PRB RESULTS 5/2/24 (FAA)

(SBA) SANTA BARBARA, CALIFORNIA, SANTA BARBARA MUNI
GAUCH THREE (RNAV) DEPARTURE <https://swims.faa.gov/Procedure/Edit/8709>

Subject: Approval Request: Santa Barbara Muni (KSBA), Santa Barbara, CA

GAUCH THREE DEPARTURE (RNAV)

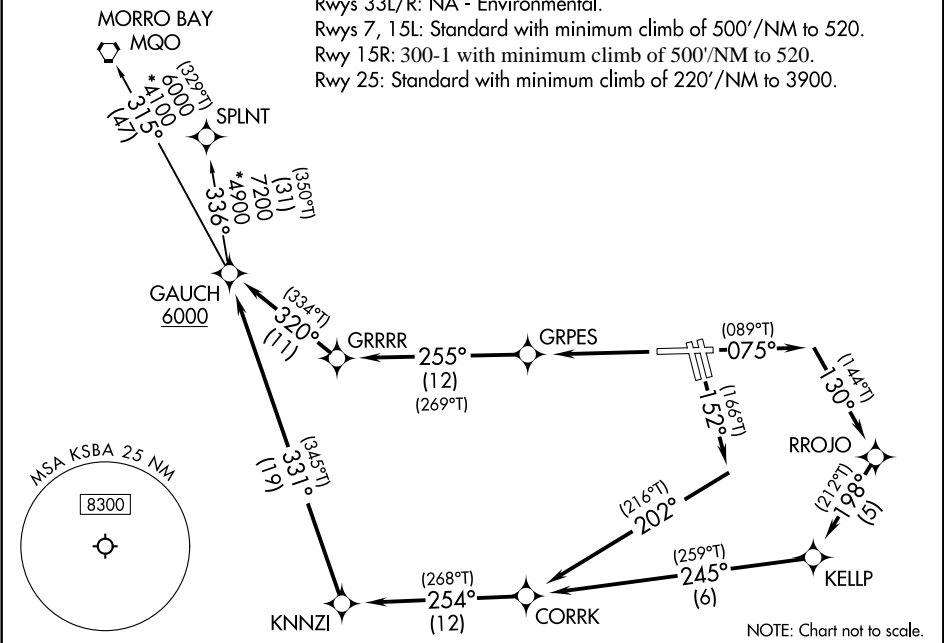
Rwy 15R: The TARGETs computed CG/CGTA required to mitigate a see-and-avoid area obstacle penetration is 1107 ft/NM to 211 ft MSL. Rwy 15R DER elevation is 11.0 ft MSL.

The obstacle requiring the CG/CGTA is 163 ft MSL TREE (06-289558) 342457.46N/1195022.72W AC 1A. The obstacle is located 0.2477 SM from DER (1097.9418 ft from DER along centerline/760.9281 ft to the right). The obstacle is 152 ft above DER elevation and penetrates the OEA by 93.3593 ft. The airport is not able to remove the obstacle currently.

Request approval to publish 1107 feet per NM to 300 for the Rwy 15R departure. Should this approval not be granted, request approval to accomplish this takeoff using a ceiling and visibility only requirement of 300 - 1.

KSBA (SBA)
SANTA BARBARA MUNI
SANTA BARBARA, CA
GAUCH THREE (RNAV) SID

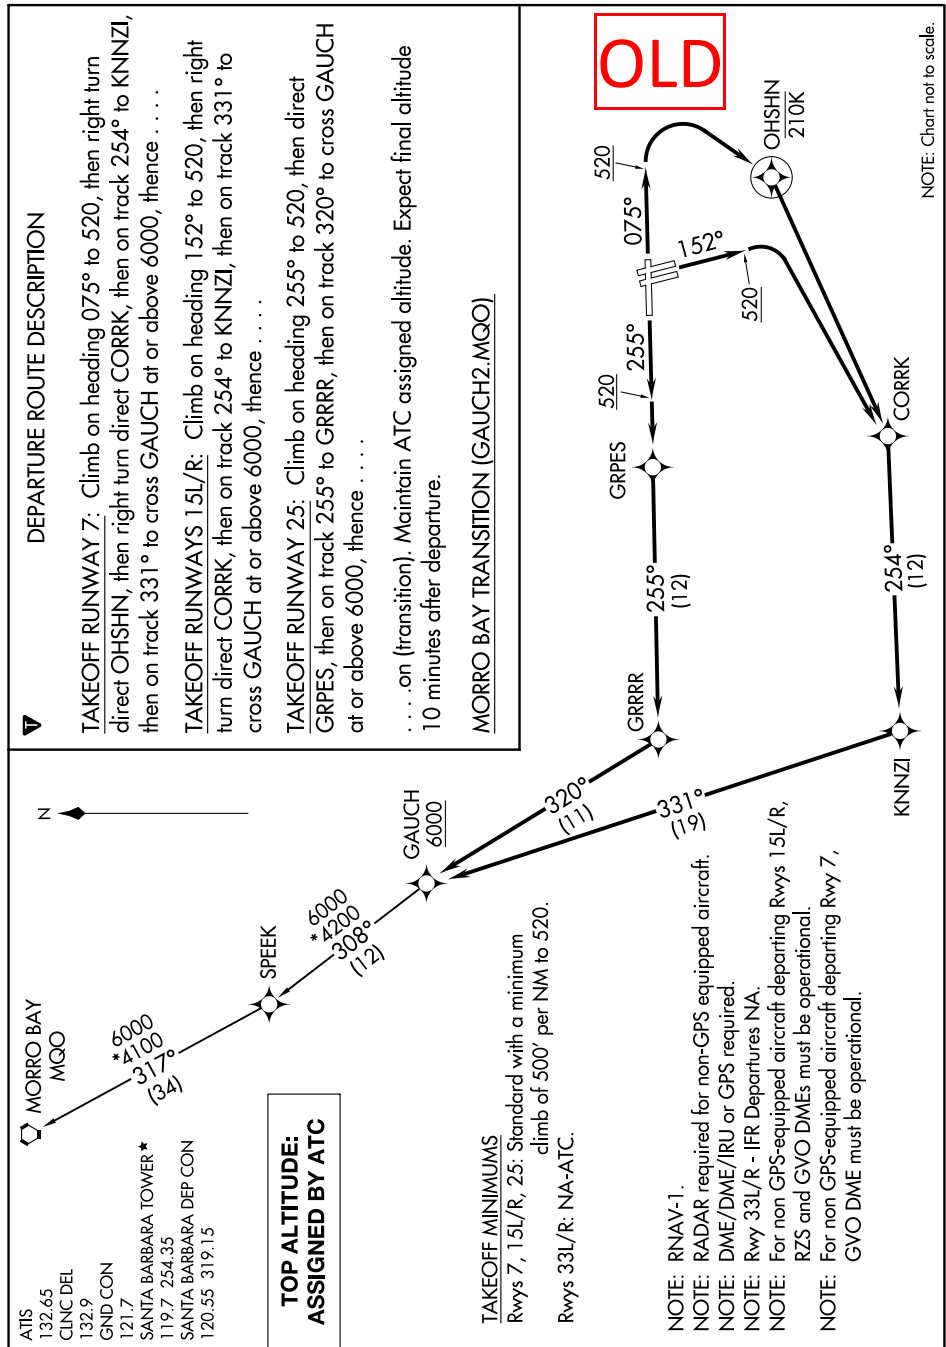
1. TOP ALTITUDE: SHOULD BE AT LEAST 10,000 FT BASED ON AT OR ABOVE RESTRICTION AT BOILE – IAW 8260.46j, 2-1-1.(F)

PRB Result: Approval Request to publish ceiling and visibility only (300-1) approved.
